Southern California Edison
San Joaquin Cross Valley Loop Project A.08-05-039

DATA REQUEST SET SJXVL CPUC-ED-03

SAN JOAQUIN CROSS-VALLEY RECTOR LOOP PROJECT: POWER FLOW ANALYSIS OF ROUTING OPTIONS

The three routing options have been identified by the SCE Rector Loop project team through extensive analysis of the SJV area. The following analysis is based on the most recent data on the routing alternatives as of December 12, 2005.

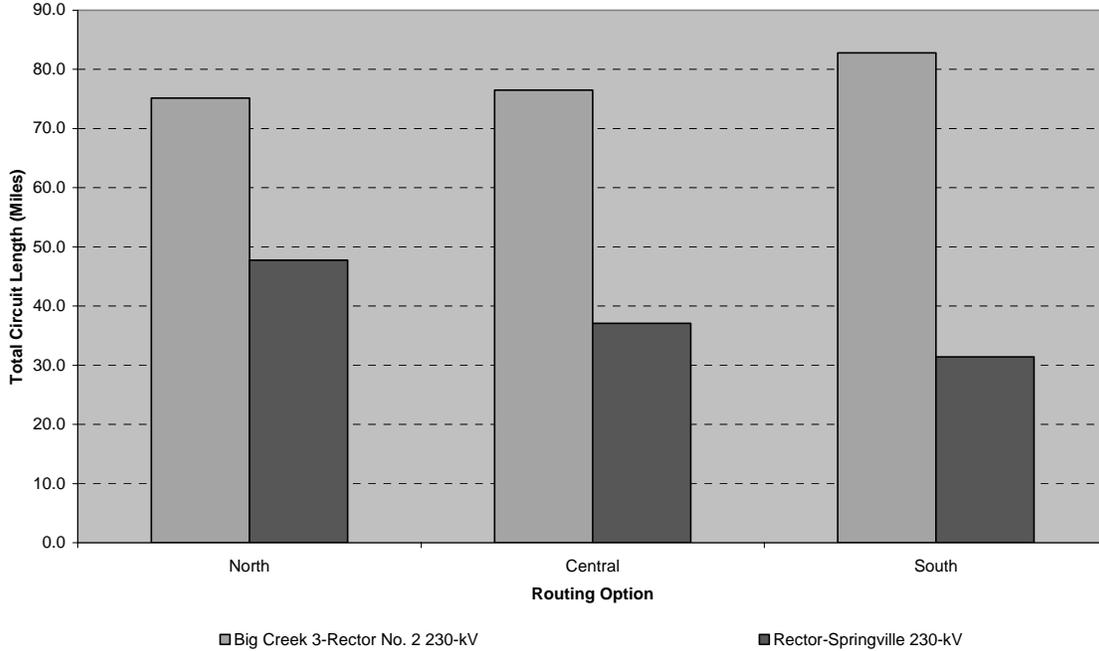
- d. Please provide studies and associated data that was relied upon in reaching the decision in the PEA that "...the Alternative 4 route is the least effective at meeting the project objectives of increasing transmission line capacity between Big Creek..."(PEA, pg 2-9).

In reference to the attached document, please note that the document was prepared in late 2005, approximately a year before the SJXVL open houses and over two years prior to finalization of the SJXVL PEA. As such, route names in this document are **inconsistent** with route names presented in either the SJXVL fact sheets or the SJXVL PEA. This

document - and this document only - identifies three route alternatives by numbers in increasing order from north to south. The route referred to in this document as route #1 actually corresponds to "Route Alternative 2" in the PEA. Likewise, the route referred to in this document as route #2 actually corresponds to "Route Alternative 1" (the Proposed Project) in the PEA, and the route referred to in this document as route #3 actually corresponds to "Route Alternative 4" in the PEA. This document does not address electrical performance of the northernmost "Route Alternative 3" because this route was not under consideration in 2005. As stated in the PEA (see Appendix E), Route Alternative 3 was developed based on the questions, comments and suggestions received from the public during the November 2006 and January 2007 open houses. Finally, route descriptions in this document (including lengths and impedances) were based on conceptual routes and information available at the time the document was prepared (i.e. December 2005). Therefore route descriptions in this document are approximately equivalent but not necessarily an exact match to the route descriptions in the SJXVL PEA, the SJXVL fact sheets, or information provided in responses to previous CPUC data requests.

There are two significant differences between these routes from a transmission planning perspective. The first difference is the location of the “tap point” where the new transmission construction will meet with the existing Big Creek 3-Springville line. These locations range from 12.6 miles north of Springville (the “southern” route) to 24.6 miles north of Springville (the “northern” route).

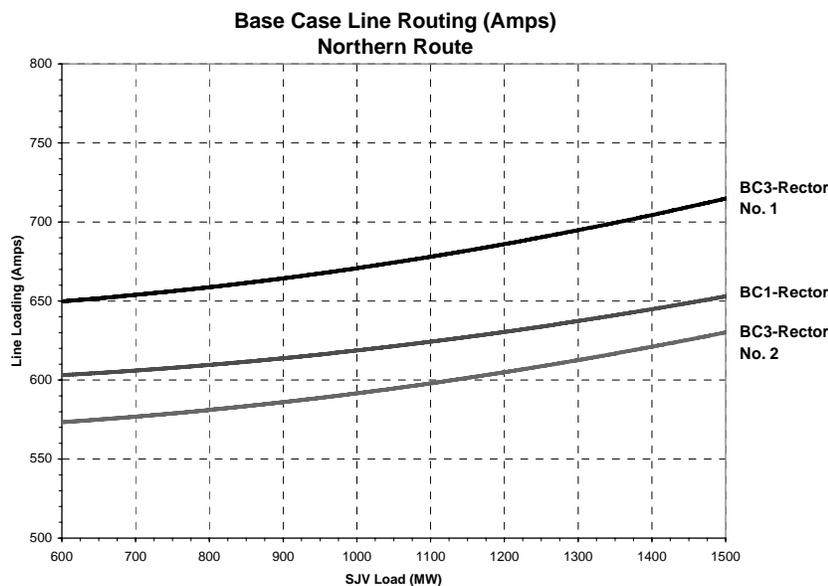
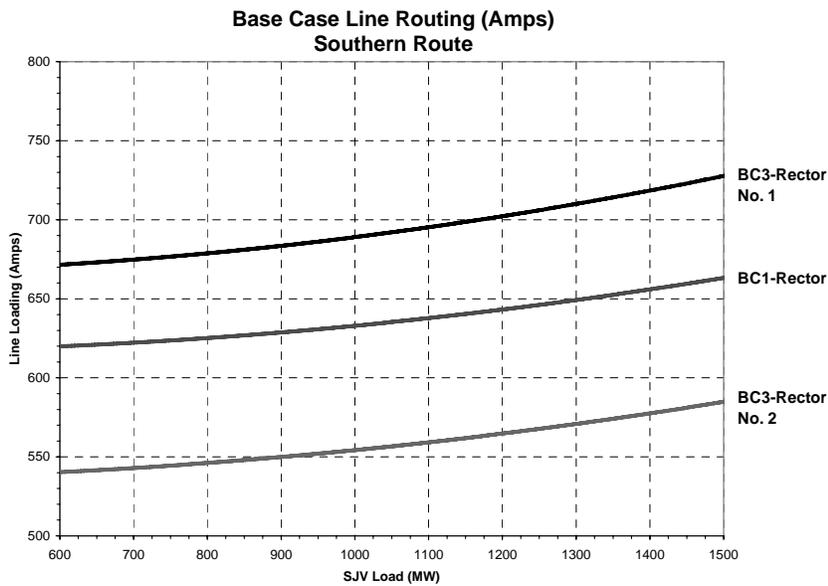
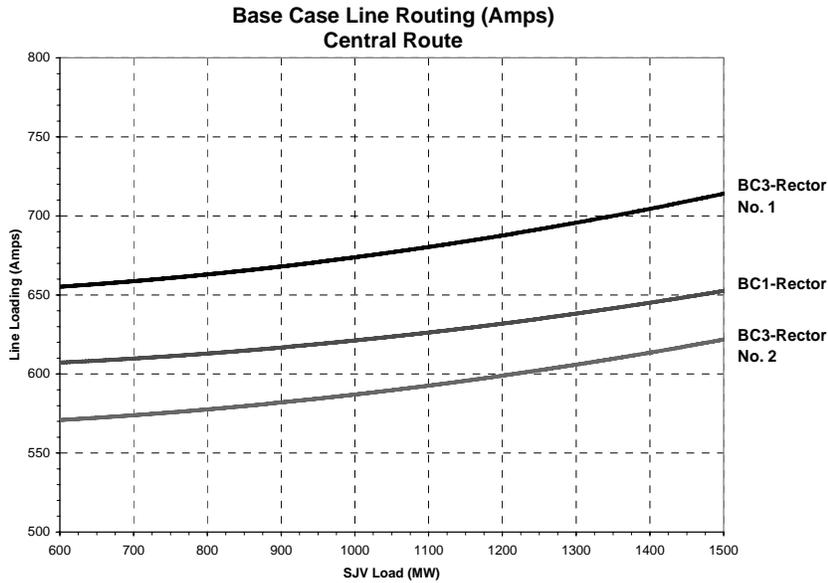
- e. For peak loading condition at Rector Substation, what is the peak power that would need to be transmitted over the Rector - Springville segment of the proposed Big Creek 3 loop line to Rector (Rector Springville line) for preventing line overloads and maintaining the capacity and stability of Rector Substation in the event of an outage on the Big Creek 3 - Rector segment alone or in conjunction with any of the other 220 kV lines of the Big Creek to Magunden transmission system? Would line impedance for line lengths ranging from 29 to 55 miles, depending on the route alternative chosen, be a critical factor limiting the needed capacity of the Rector - Springville line? Four scenarios should be addressed:

The northern route results in the highest base case loading of the new Big Creek 3-Rector No. 2 230-kV line and the lowest loading of the two existing lines from Big Creek to Rector. These two existing lines represent the most “limiting components” of the San Joaquin Valley transmission network as it exists today. Furthermore, as the Rector Loop routing is moved further south, loading on the existing lines increases and loading on the new Big Creek 3-Rector No. 2 230-kV line decreases.

The three graphs above show that the southern route results in the most unequal loading on the three lines serving Rector load from Big Creek, particularly between the (existing) Big Creek 3-Rector line and the (new) Big Creek 3-Rector No. 2 line. In other words, the existing lines load significantly higher than the new line. One way to quantify the amount of unequal line loading between the two Big Creek 3-Rector lines is to use the following formula:

Big Creek 3-Rector No. 1 & No. 2 Unequal Line Loading
 (expressed as percent of total Big Creek 3-Rector line flow)

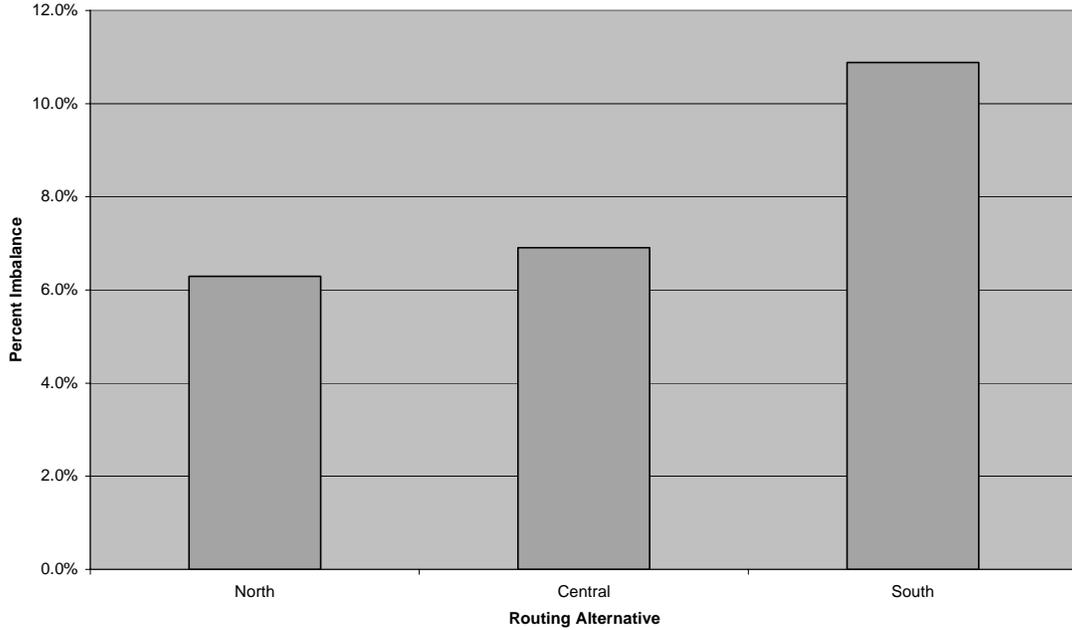
g. Could the differences in system electrical performance of Route 1 vs. Routes 2, 3, or 4 operating normally or during critical outages be considered a wash? If not please explain.

In terms of most efficient use of transmission facilities to serve SJV load, the northern and central routes are comparable to each other under base case conditions, with the northern route resulting in the maximum utilization of the new transmission capacity created by the project. Furthermore, unequal line loading increases significantly as the line route options continue south, with the southern route resulting in approximately 1.75 times the unequal line loading of the northern route.

**N-1 Outage of Big Creek 1-Rector 230-kV Line
SPS Runback of Eastwood/Mammoth in Service**

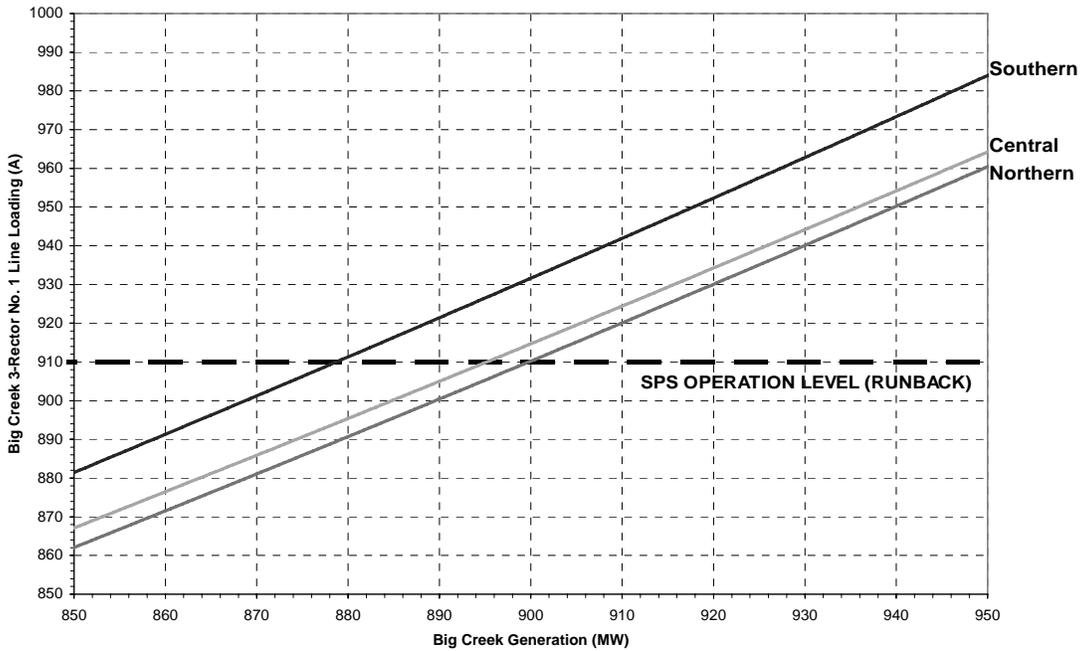
f. Would 7 miles of increased length (and impedance) for the Big Creek 3 - Rector portion, of the Big Creek-Rector-Springville loop, have as much detrimental effect on the system and Rector Substation performance as would a similar increase in length of the Rector-Springville segment? Explain why.

The results indicate that the northern route will result in the least amount of exposure to potential generation reduction for the N-1 contingency outage in question and that the southern route will result in the greatest amount of exposure. The graph below summarizes the loading on the Big Creek 3-Rector No. 1 line upon the Big Creek 1-Rector N-1 outage assuming approximately 1500 MW of SJV load.

Upon the N-1 outage of the Big Creek 1-Rector 230-kV line, the northern route results show the lowest exposure to potential reduction of Big Creek generation for thermal overload reasons. In contrast, the southern route results show the greatest exposure to potential generation reduction under the same outage condition. A chart summarizing the amount of exposure under these conditions is presented below.
